Re: Infill House
Pulaski Square
Savannah, Georgia
Project No. 90024

DECISION ITEMS - PULASKI SQUARE INFILL HOUSE
PROJECT NO. 90024

Re: Beehive Press Foundation
Pulaski Square Infill House
North West corner of Barnard and Harris Streets
Savannah, Georgia

WINDOW LATCHES - HARDWARE SCHEDULE SUPPLEMENTARY DETAIL

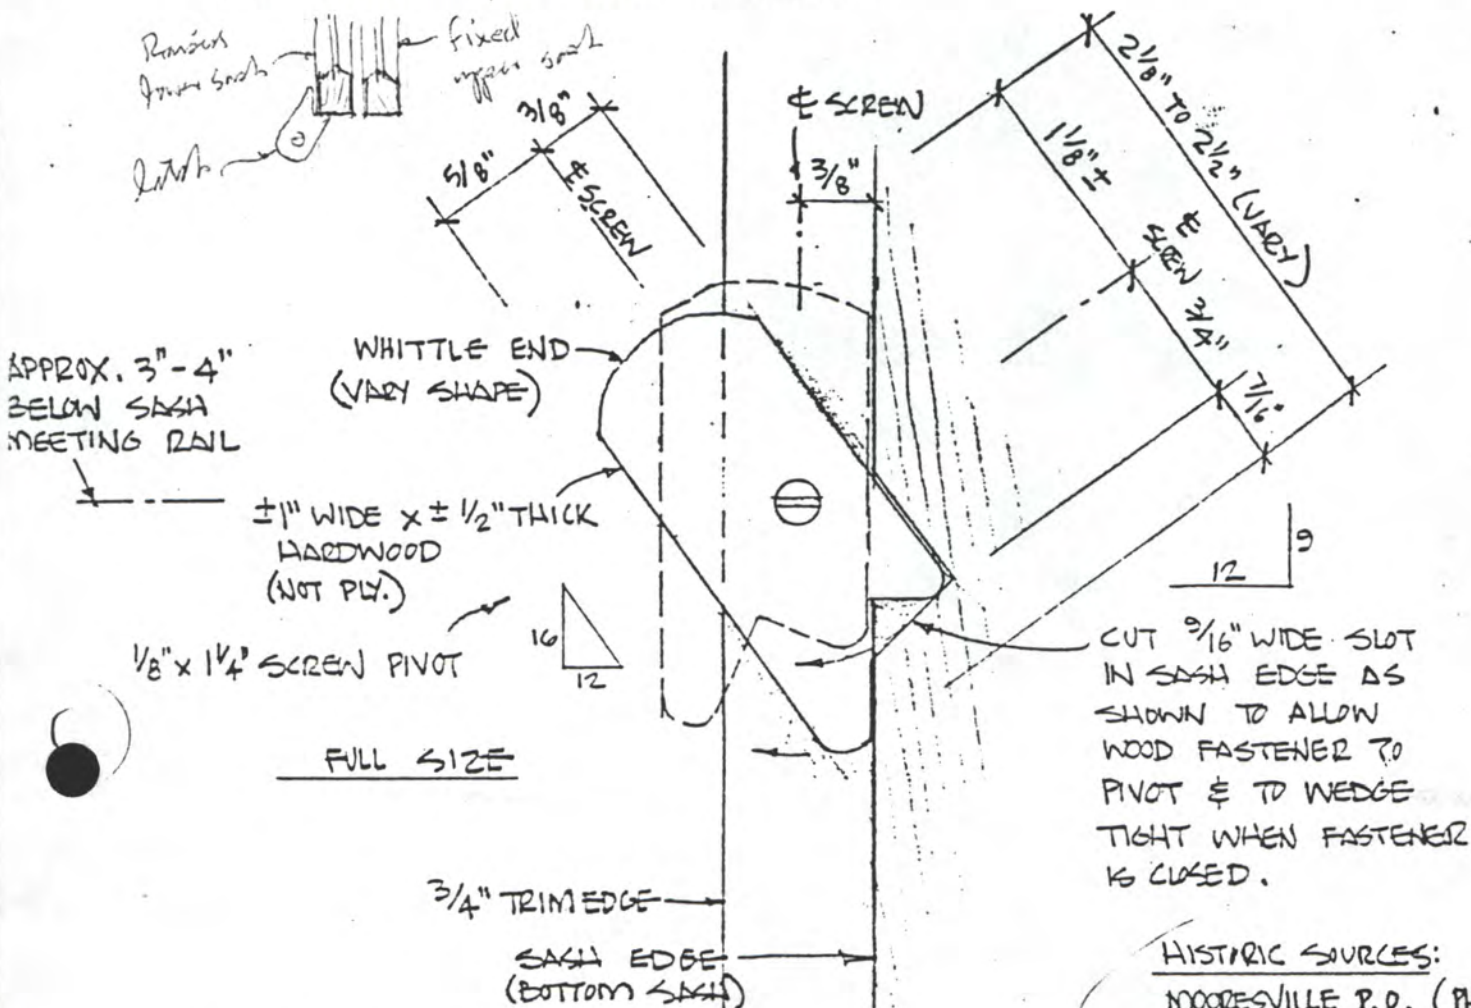
NOTE: DELETE METAL SASH LATCHES & SUBSTITUTE THE FOLLOWING FOR BEST HISTORICAL ACCURACY:

1. SEE PHOTO 59 FOR EXAMPLE.
2. MAKE 1 WORKING EXAMPLE FOR ARCH. APPROVAL BEFORE MAKING ALL. PROVIDE 2 PER SASH AS SCHEDULED
3. PROVIDE 2 1/2" NAIL, STRING & HOLE" SASH LATCHES PER SASH PER PHOTO 59 WHERE SCHEDULED.

USE 2" CUT NAIL, HEAVY COTTON STRING, DRILLED HOLE. THE STRING TO CUT NAIL IN JAMB, PER PHOTO 59.

DESIGN FOR WINDOW

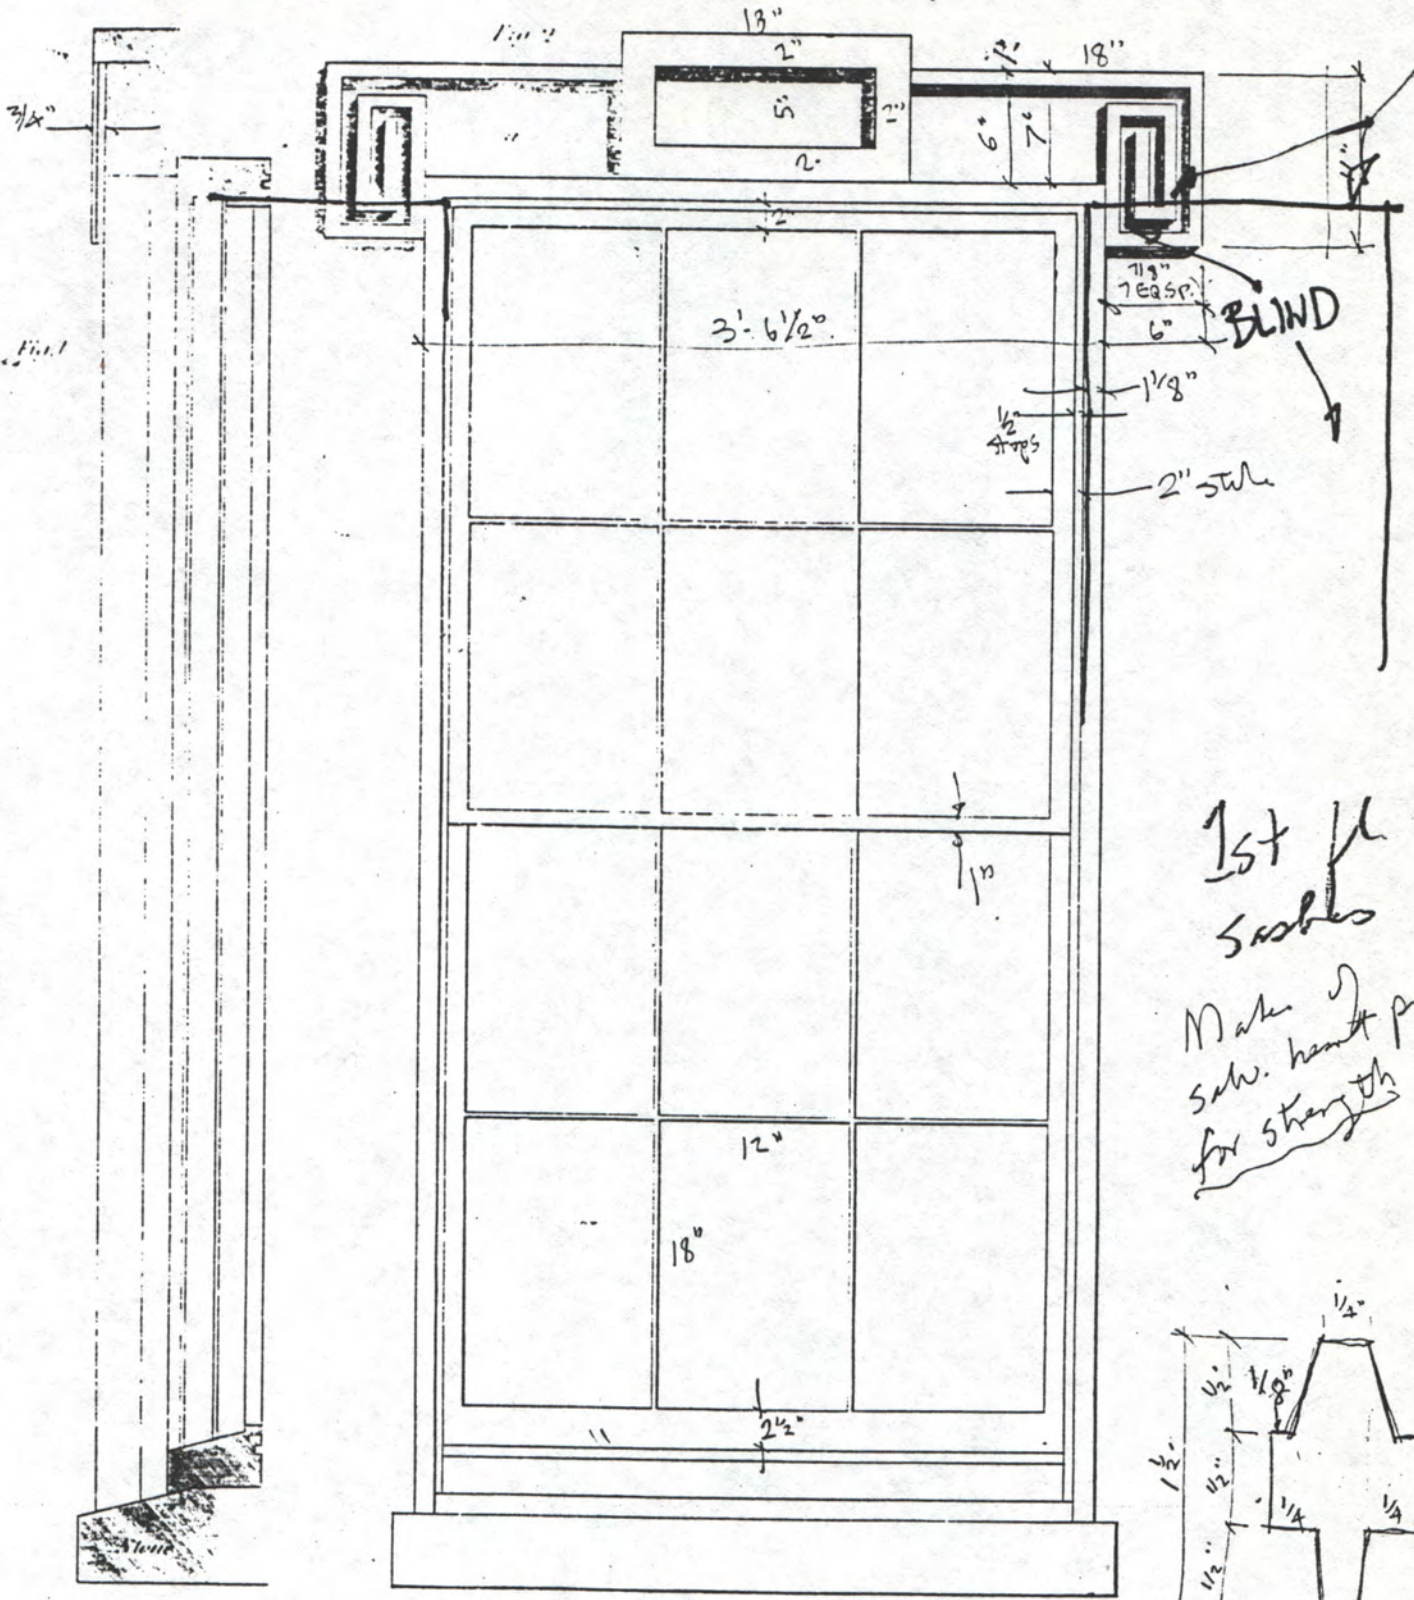
Mills - The blinds will partially cover the lintel ends. OK?
AS 16 Jan. '91

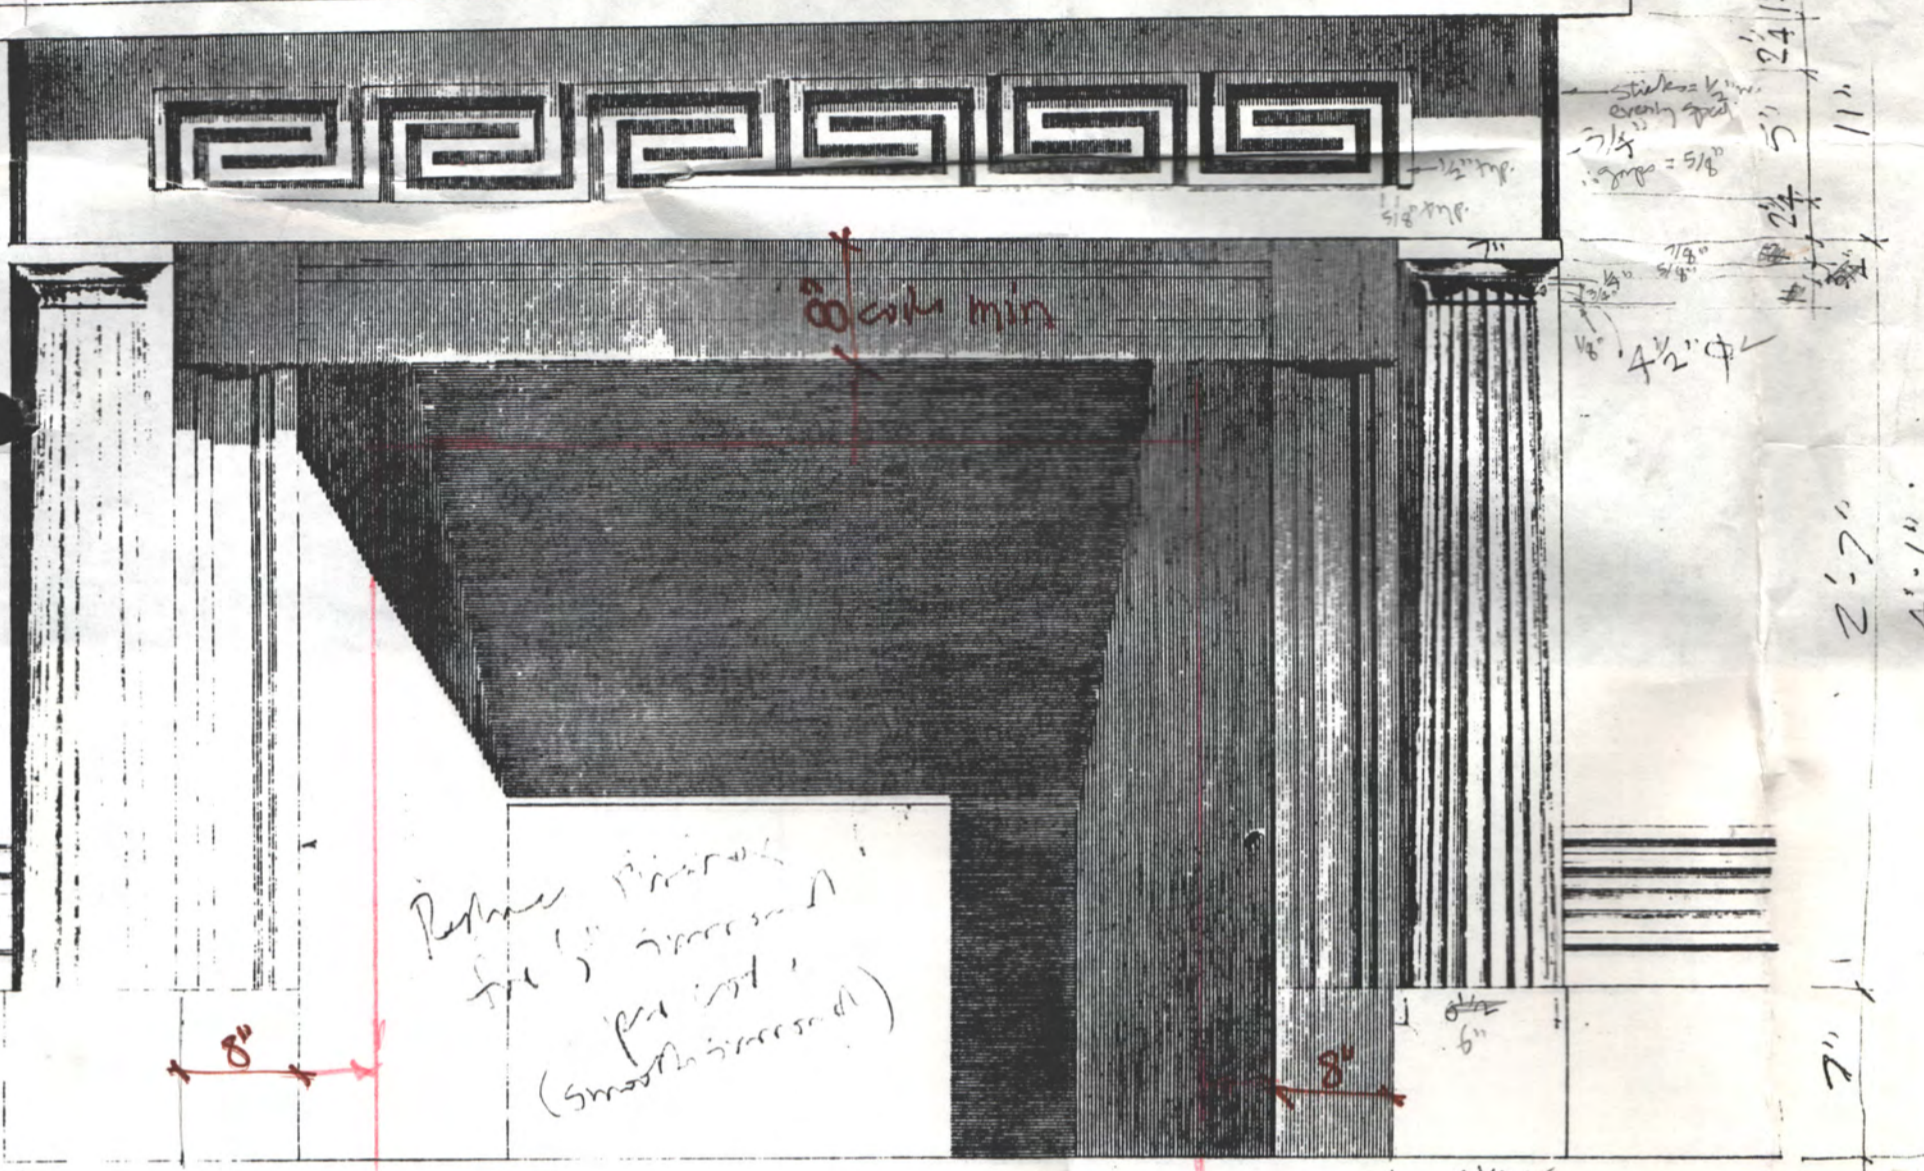
Colonnets only at level 2
 Pilasters at level 3
